Catfield Fen Water Abstraction
Report by Senior Ecologist

Broads Authority response to the Environment Agency's Groundwater report and Appendix 12

Independent review completed for the Broads Authority by Professor Ken Rushton on the Environment Agency Summary Groundwater Report: Assessment of the Acceptable Level of Abstraction within the Ludham-Catfield Area in the Vicinity of the Ant Broads and Marshes SSSI

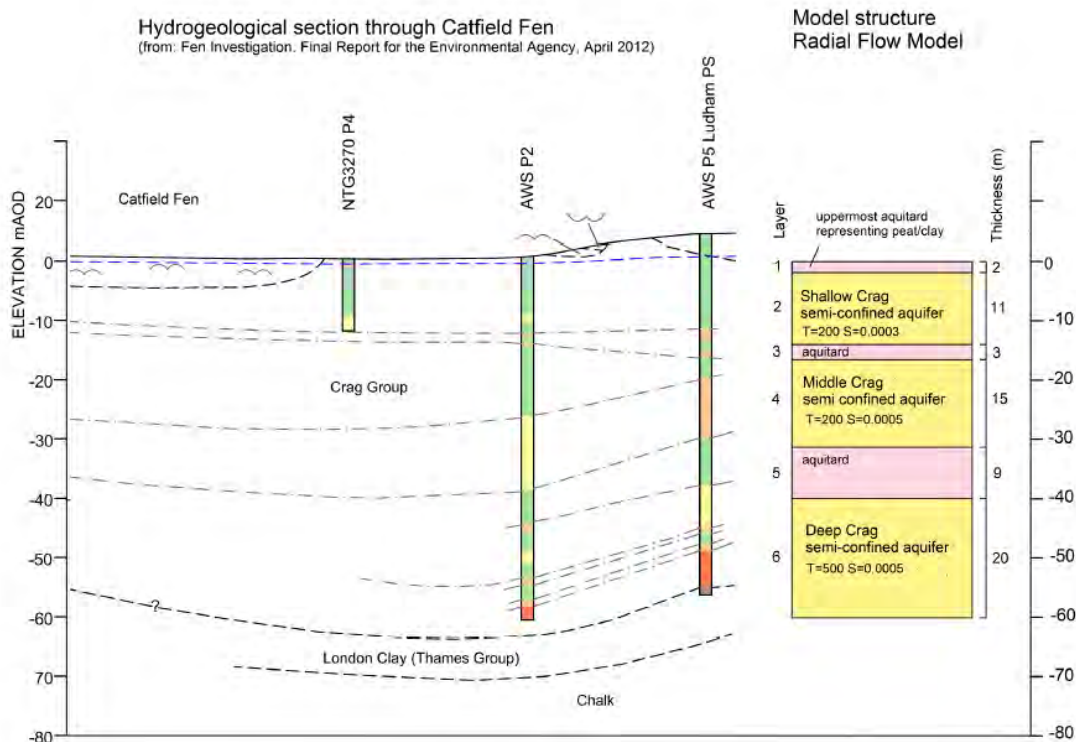
- Aquifer parameters have been adjusted so that there is reasonable agreement between modelled and field values.
- There is a disturbing and confusing statement about the “*surface aquitard which represents the uppermost peat and the locally underlying estuarine clays of the Ludham-Catfield Fen area. This confining layer (Layer 1) is required in order for drawdown predictions in the shallow Crag (Layer 2) to be generated, as no response is predicted for this layer when the overlying confining layer is removed. The effect of this assumption is that groundwater is not drawn from unconfined storage in the Shallow Crag. If this larger storage is used, the model predicts that the drawdown in water levels in the upper layers is less than 0.001 m.*” So where does the water originate? Does it all come from the outer fictitious boundary at 10 km? There is no physical explanation or diagram to help the reader to understand what has been done to achieve a drawdown in Layer 1.

- Appendix E (copied above) shows a cross section (with no defined horizontal scale) from the pumped borehole to Catfield Fen and also the idealised section used in the model in which layers are continuous. Since radially symmetrical conditions are a basic assumption, the model assumes that Catfield Fen is effectively cylindrical in plan with an inner radius of about 1 km and an outer radius of perhaps 2 km. Furthermore, identical aquifer properties and conditions appear to apply at every radius out to a distance

of 10 km. An examination of Figure B2 of the AMEC Catfield Fen Investigation Final Report (April 2012) shows that the assumption of radial symmetry is far from correct. Also Section 4.2 of that report indicates that the layering may be discontinuous.

- It is unclear what condition is applied in the model at the uppermost aquitard which represents peat/clay
- There are two aquitards within the Crag, the upper one 3 m thick with a vertical permeability of 0.0008 m/d, the lower aquitard is 9 m thick with a vertical permeability of 0.004 m/d. These vertical permeabilities used in the radial flow model are very low, especially the upper aquitard. With horizontal hydraulic conductivities of the aquifer in excess of 10 m/d, this very low permeability aquitard forces the effect of pumping to spread to significant radial distances.

- A more reliable and informative analysis of this pumping test could be carried out with a three-dimensional model, similar to that used for the NEAC model, with a finer mesh spacing in the vicinity of the pumped borehole, with a radial flow correction at the cell containing the pumped well and with boundary conditions deduced from the regional model. This approach would allow a far more realistic representation of ground surface/water table conditions.

Figure 7.1 Groundwater Level Data Collected from UOB13 and UOB14 - Model Calibration

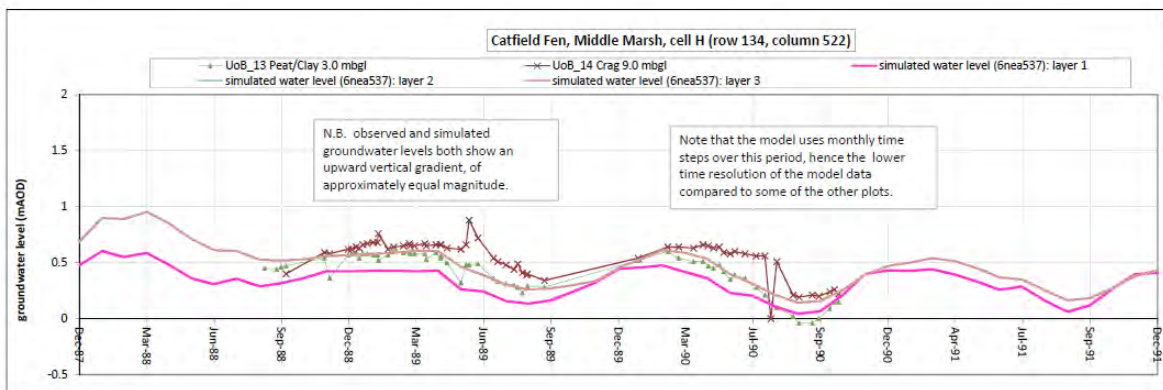
- Fig. 7.1 of the Summary Report refers to groundwater heads recorded in piezometers at depths of 3.0 and 9.0 mbgl in Middle Marsh from August 1988 to October 1990; these results are compared with NEAC results for Layer 1 and Layer 3. A note on Fig.7.1 suggests that observed and simulated groundwater levels show an upward vertical gradient of approximately equal magnitudes (information is not provided about the difference in elevations of Layer 1 and 3). However, a careful examination of the results in Fig. 7.1 (especially for 1990) indicates that the differences between shallow and deep piezometers are often not replicated by the differences in the corresponding model results. Consequently the model does not accurately reproduce the observed head differences in the piezometers.

Figure 7.2 Groundwater Level Data Collected from Dipwells Within the Catfield Fen Internal System on the Butterfly Conservation Reserve Close to Where the Fen Orchid Has Been Recorded - Model Calibration

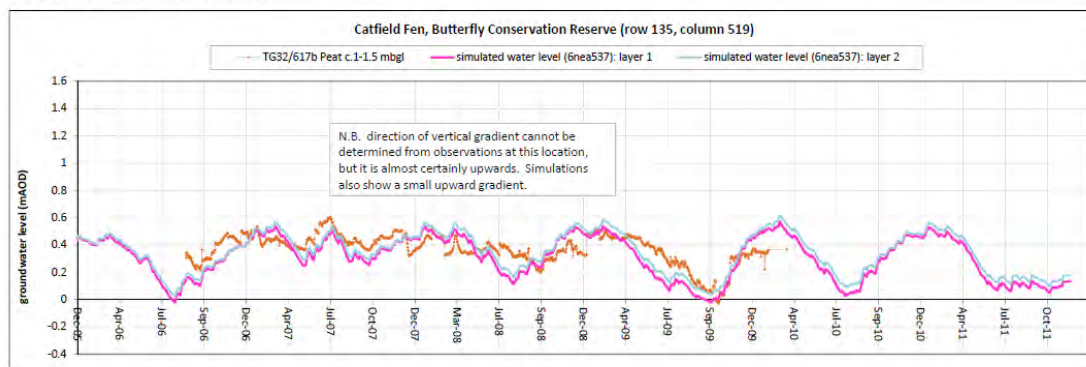
- Fig 7.2 is concerned with a dip well on the Butterfly Conservation Reserve. The figure fails to indicate that ground level is 0.371 mAOD (Table E22, AMEC 2012); for several months each year the water level in this dipwell is above ground surface indicating ponding of water. Does the numerical model simulate ponding; are capillary rises simulated? The general form of the fluctuations for field and computational model are roughly similar, but for certain periods there are significant differences with the modelled fluctuations substantially larger than those observed in the field.

Figure 7.3 Groundwater Level Data Collected from Piezometers at Different Depths Within the Crag Close to the AWS Ludham Abstraction - Model Calibration

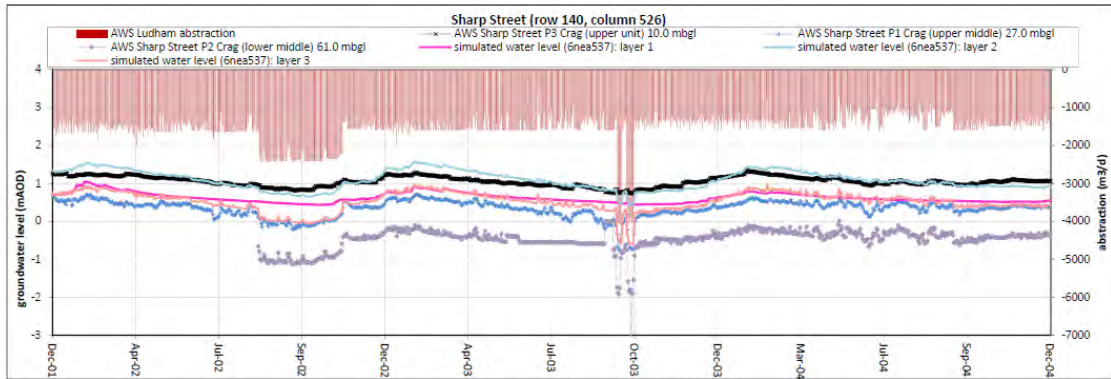
- In Fig. 7.3 comparisons are made between three piezometers in Sharp Street at depths of 10, 27 and 61 m below ground level. As explained in the box below the figure, the field results indicate downwards flow due to abstraction from AWS Ludham at a distance of about 400 m. However the downward flow throughout the upper part of the Crag is not reproduced in the numerical model. From the model results there is an upward flow from Layer 2 which is the upper part of the Crag to the water table in Layer 1

which is located in a sand layer with some gravel (Layer 1 from Appendix I AMEC 2012). On the other hand, the model does show a downwards flow from the upper (Layer 2) to the lower Crag, Layer 3. The note on Fig. 7.3 explains that in the numerical model, Layer 1 *simulates the shallow peat deposits on the arm of the fen leading to Crome's Broad* (also called Snipe Marsh) and therefore fails to represent the true physical situation for the piezometers (in fact an examination of Fig. 1.2 suggests that the shallow peat deposits are only a small part of that grid square). If a closer grid spacing was used it would be possible to represent the actual field conditions at the location of these piezometers.

Figure 2.1 Capillary Rise of Shallow Groundwater to the Root Zone

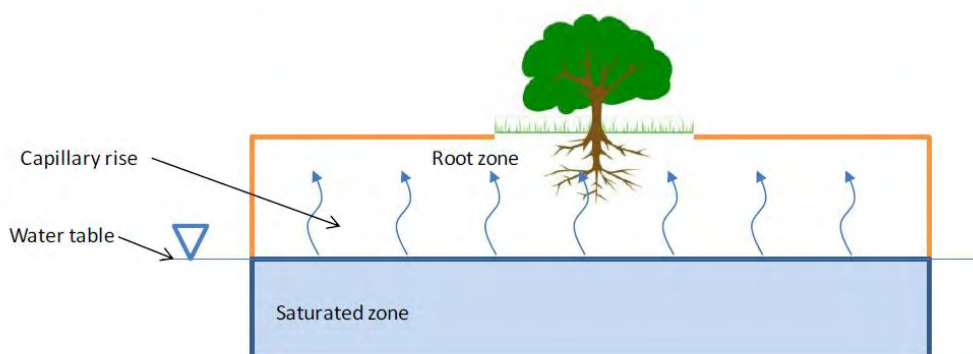
Fig. 2.1 of the Technical Note illustrates the capillary rise of water from a water table (which is below the root zone) upwards to the root zone. Is this the only condition for which this approach is applicable? Alternative approaches in the literature for estimating the capillary rise are quoted.

A conceptual diagram is urgently required which illustrates the **real** conditions on the surface of a fens showing all the component processes including precipitation, evapotranspiration or evaporation from ponded water, the transfer of water laterally including to drains and variations in the extent of the saturated zone.

Figure 5.7 Modelled and Measured Water Levels and Soil Moisture Content: TG32/617b

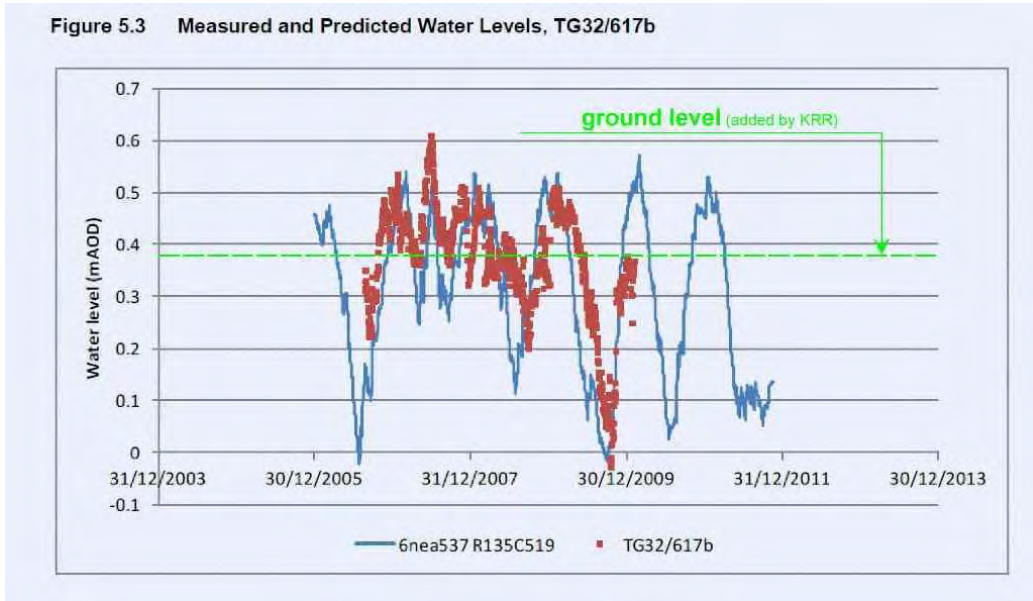
Returning to the approach described in this Technical Note, Fig. 5.3, copied below, shows both the field and modelled hydrographs for TG32/617b. However, in Fig. E22 of AMEC (2012), ground level at this location is quoted as 0.371 mAOD; I have added this ground level elevation to Fig. 5.3. Both the field and modelled results indicate that the water level is above the ground surface for many months each winter. Consequently I cannot understand how, in Fig. 5.7 of the Technical Note (also copied below), the moisture content does not equal 100% for these periods. Is the ground surface elevation included in the calculation method of Section 4? From a comparison of the vertical scales of Fig 5.3 and the upper diagram of Fig. 5.7, it appears that *the base of the root zone* in the computational model is mistakenly set close to *the actual ground level* in the fen.

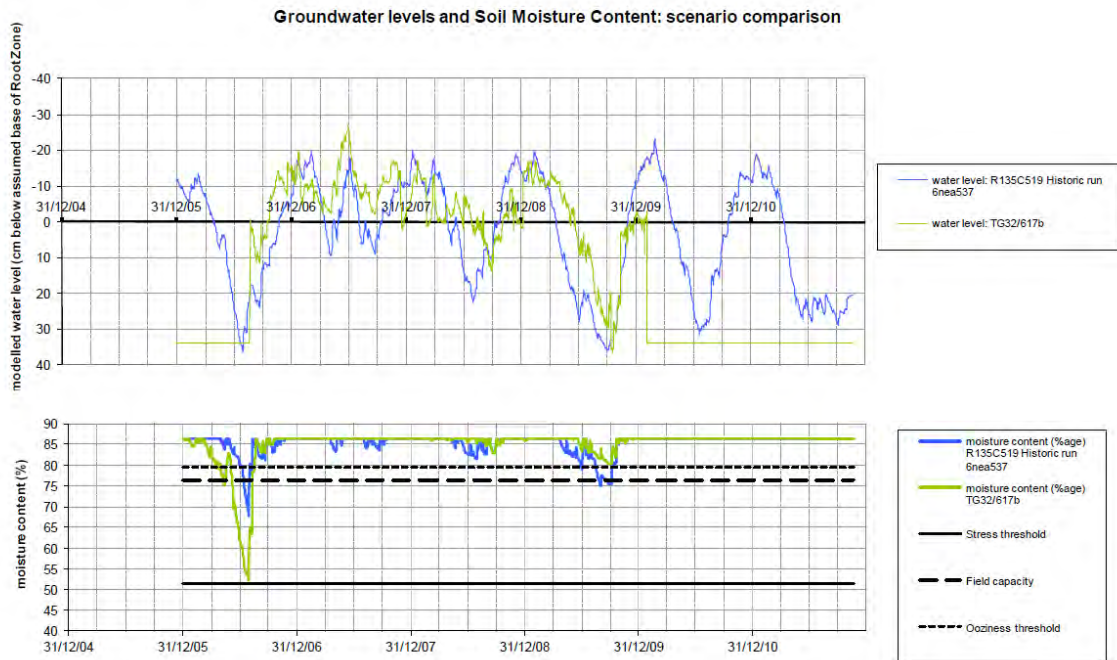
Ponding of water occurs regularly in certain parts of the fen; is it represented in the NEAC model? de Silva and Rushton (2008) describe a study of flooded ricefields using a soil water balance model which incorporates ponding. In ricefields, ponding occurs because downward movement of water out of the bottom of the soil layer is restricted due to the presence of a puddled layer. In the water balance calculation, negative soil moisture deficits represent ponding. A limit is placed on the negative soil moisture value; if it becomes too high, this is equivalent to overtopping the bund.
